Re: Major Project 08_0116 – Civil Works Stage 2 – Potts Hill Reservoir Site

I write in response to DECCW's letter of 3rd February 2010, which contained a number of comments to the Department of Planning on the Potts Hill Major Project (MP 08_0116) for Civil Works Stage 2. This letter provides a response solely relating to matters relevant to allow the proposed Conservation Agreement on the Sydney Water retained lands to proceed to exhibition.

Figure 1 – Conservation Areas

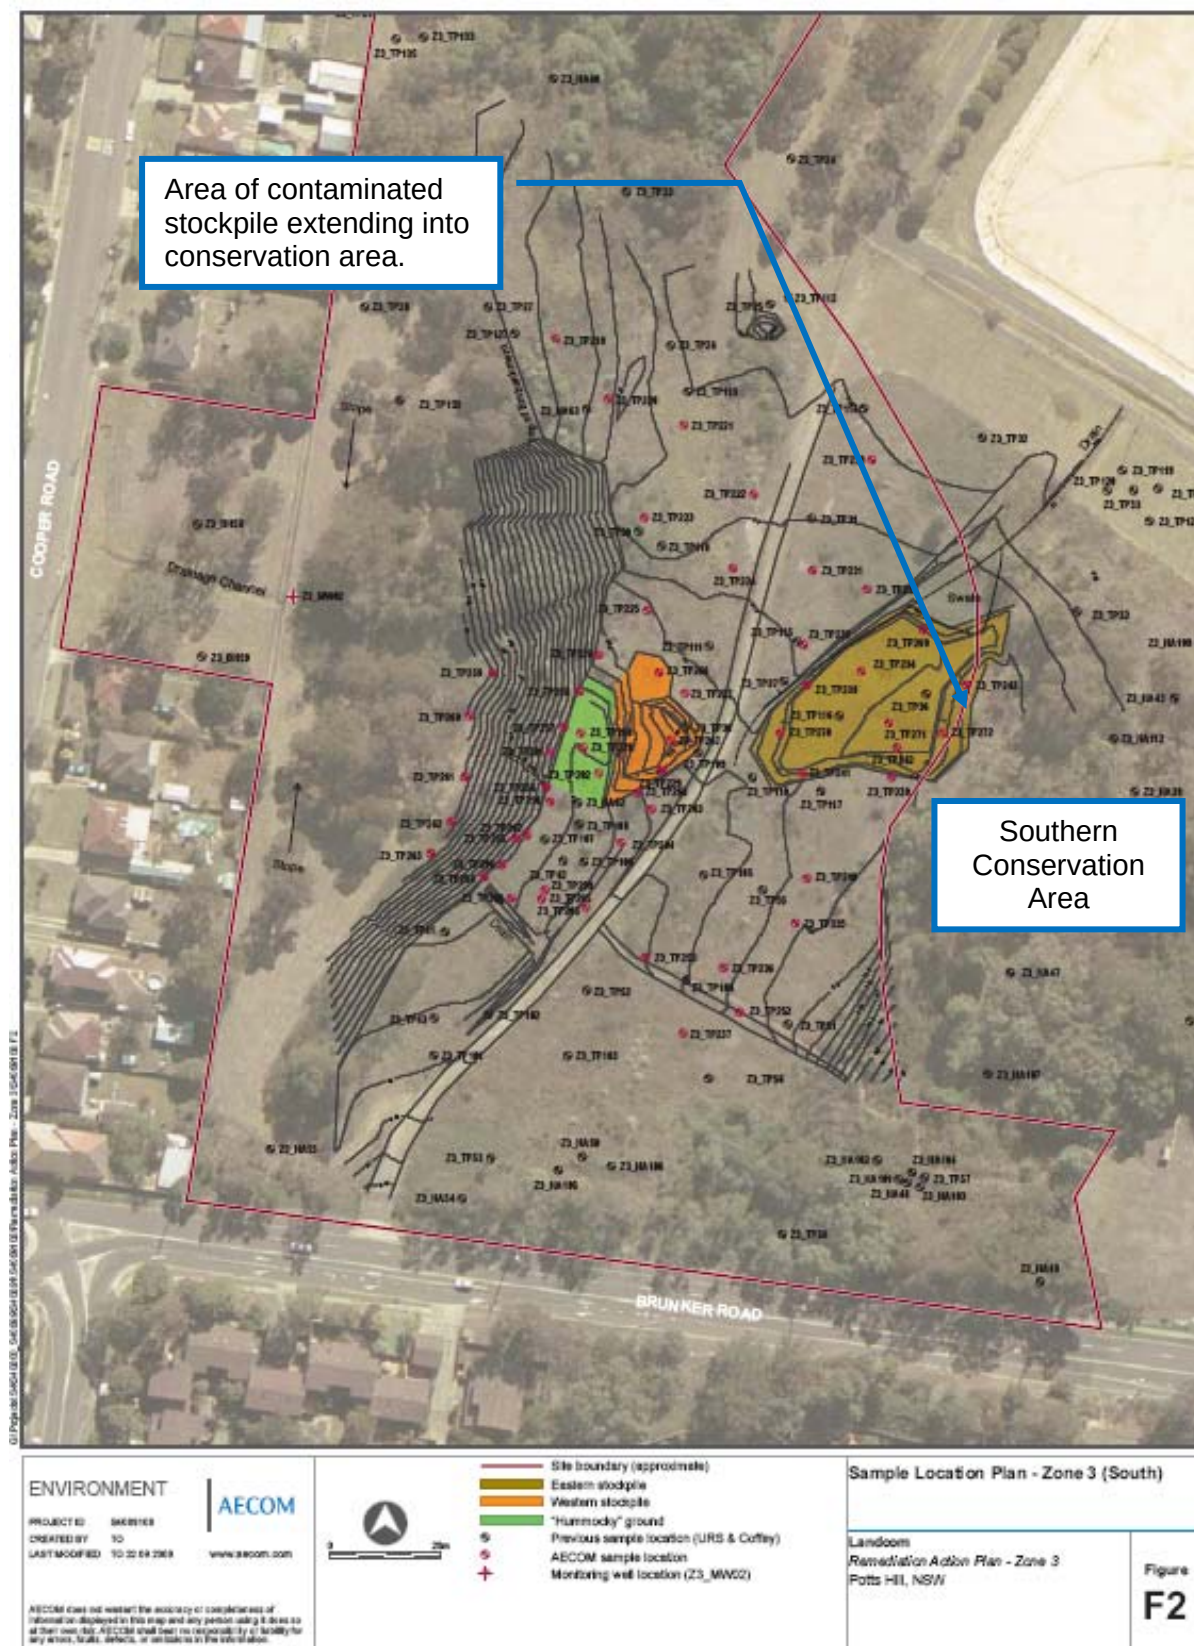
Landcom acknowledges DECCW's request that infrastructure, including all stormwater (eg. overland flow channel/swale), fencing and earthworks be removed from the Conservation Agreement lands.

Landcom acknowledges that DECCW seeks an offset ratio of 3.3 : 1 or greater. DECCW noted that the detailed plans show an increased loss of vegetation from 1.03 to 1.42 hectares of endangered and critically endangered ecological communities. They also identified concerns about a number of matters relating to the latest offset calculation, which were:

1. Vegetation intended to be retained to the north of the stormwater detention basin in the Brunker Road Park (basin no. 3) being impacted by batters associated with this basin. DECCW recommends that the offset ratio is recalculated excluding this vegetation.
2. Seeking advice on changes in the boundaries of the Conservation Agreement lands and a reduction from 5.24ha to 4.99ha of EECs within these lands.
3. The Ecological Assessment (page 17) identifying that 0.24ha of Cumberland Plain Woodland (CPW) will be contained within the Conservation Agreement lands, and that this vegetation should be excluded from the offset ratio calculations.

Landcom agrees to remove all proposed infrastructure from the Conservation Agreement lands, and to amend all plans to exclude all infrastructure from the Conservation Agreement lands.

1. On review, it is acknowledged that there will be considerable disturbance to the vegetation to the north of basin no. 3. The area of additional vegetation affected, beyond that previously being treated as a loss, is 0.05ha. This vegetation will be treated as a loss for the purposes of the revised offset calculation (below).

2. It is acknowledged that the calculated total area of EECs within the Conservation Agreement lands has reduced. These adjustments to the calculated area occurred after the boundaries were traversed by one of Eco Logical Australia's ecologists, Dr Steven Ward, and surveyors. As DECCW would be aware, vegetation mapping, such as used for the Potts Hill assessment, is usually a combination of aerial photography and ground truthing to define the type and extent of vegetation communities. In this instance the subsequent more accurate boundaries from the survey data identified some differences to the previously mapped vegetation boundaries. To maintain consistency with previous assessments the mapped vegetation boundaries were not altered, but the surveyed Conservation Agreement lands boundary was utilised for calculation purposes. Also, in one location setbacks required by Sydney Water from the key water supply canal from reservoir 2 to water supply pipelines in the north of the site resulted in a reduction of EEC included within the Conservation Agreement lands.

The revised offset ratio is therefore 4.99ha of EECs within the Conservation Agreement lands vs 1.47ha of EEC loss (1.42ha + additional 0.05ha to the north of basin no. 3). The revised offset ratio of gain –v- loss is therefore 3.39 : 1.
